Devices	C164CI-8R, C164SI-8R, C164CL-8R, C164SL-8R, C164xy-L
Marking/Step	Step ES-AB, AB
Package	P-MQFP-80-1 (C-MQFP-80: EES-AB only)

This Errata Sheet describes the deviations from the current user documentation.

Current Documentation

- C164 Data Sheet 1999-08
- C164 User's Manual V2.0 1999-09
- Instruction Set Manual 12.97 Version 1.2

Figure 1 Reset Configuration Source Selection

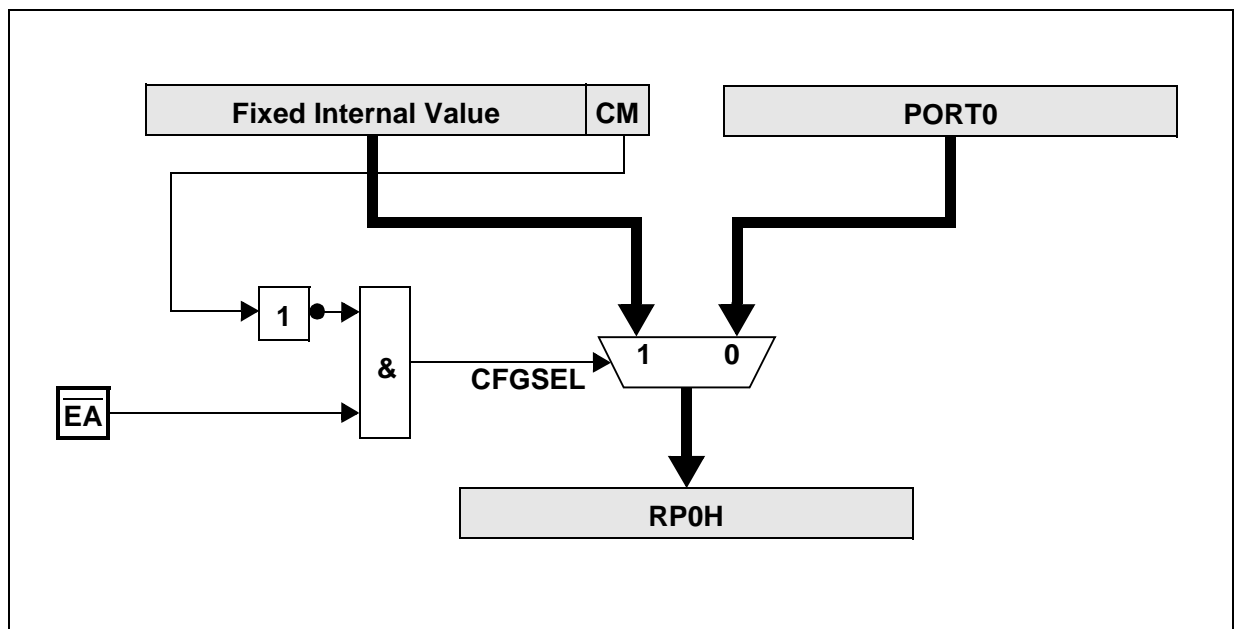
In contrast to the user's manual in the C164CI-8R the register RSTCON is not available. After single-chip mode reset the register RP0H is not set to the described default value but shows the configuration defined in the ROM mask (Configuration Byte) as follows.

For a single-chip mode reset (indicated by $\overline{EA} = 1$) the configuration via PORT0 can be replaced by a fixed configuration value. This fixed configuration value is hardwired and is selectable for each ROM mask. In this case PORT0 needs no external circuitry (pullups/pulldowns) and also the internal configuration pullups are not activated.

The logic described in the figure above controls the reset configuration source (see signal CFGSEL) in the following way:

External configuration via PORT0 is selected
 if $\overline{EA} = 0$ or if compatibility mode bit $CM = 1$ (even if $\overline{EA}=1$)

Internal configuration via fixed value (Configuration Byte) is selected
 if $\overline{EA} = 1$ and compatibility mode bit $CM = 0$

Figure 2 Internal Reset Configuration Byte

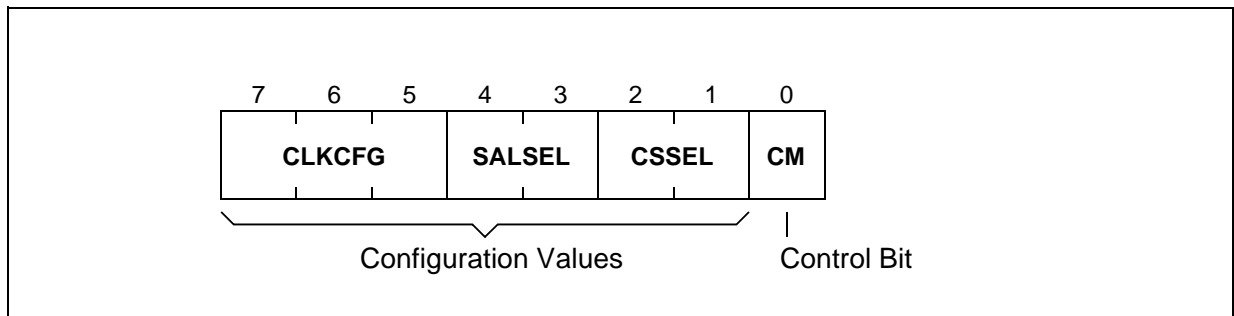
The Reset Configuration Byte (see description below) used in single-chip mode reset must be stored at location 00'003EH within the user ROM code. The Target Specification V1.0 (page 17) erroneously defines the highest ROM location.

The fixed internal value and the compatibility mode control bit CM for the Single-Chip reset are specified by a byte value described below. This byte value shall be stored at location 00'003EH within the user ROM code.

Figure 1 Structure of Output Driver with Edge Control

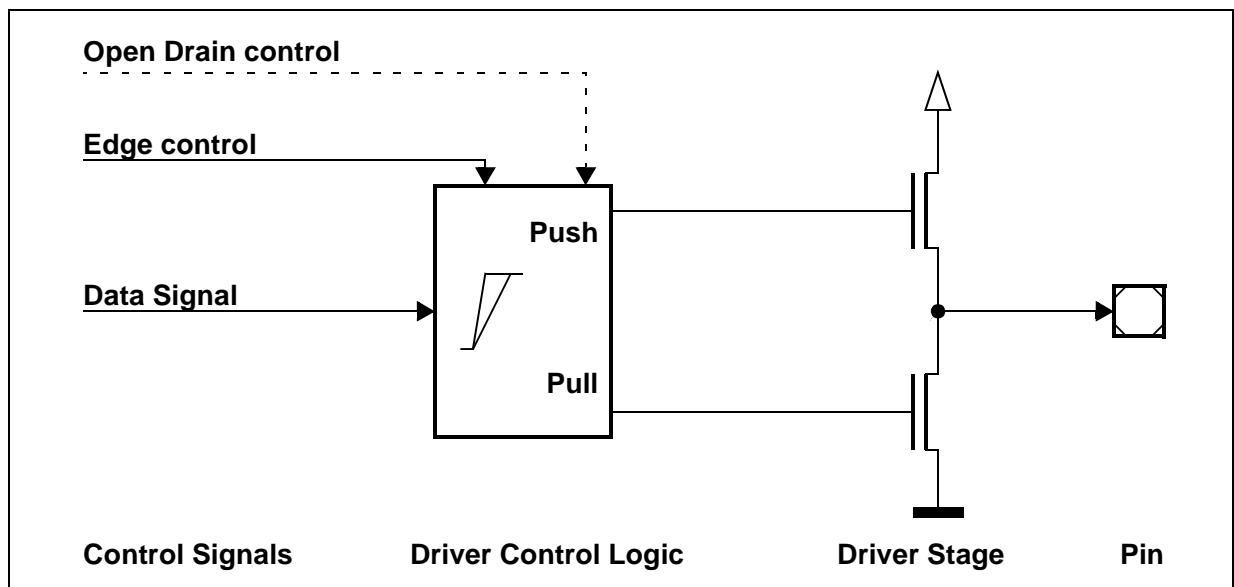
In contrast to the user's manual in the C164CI-8R the registers POCONx are not available. The output drivers edge characteristic can be configured by register PDCR instead.

The **Port Driver Control Register** PDCR provides the corresponding control bits. A separate control bit is provided for bus pins as well as for non-bus pins.
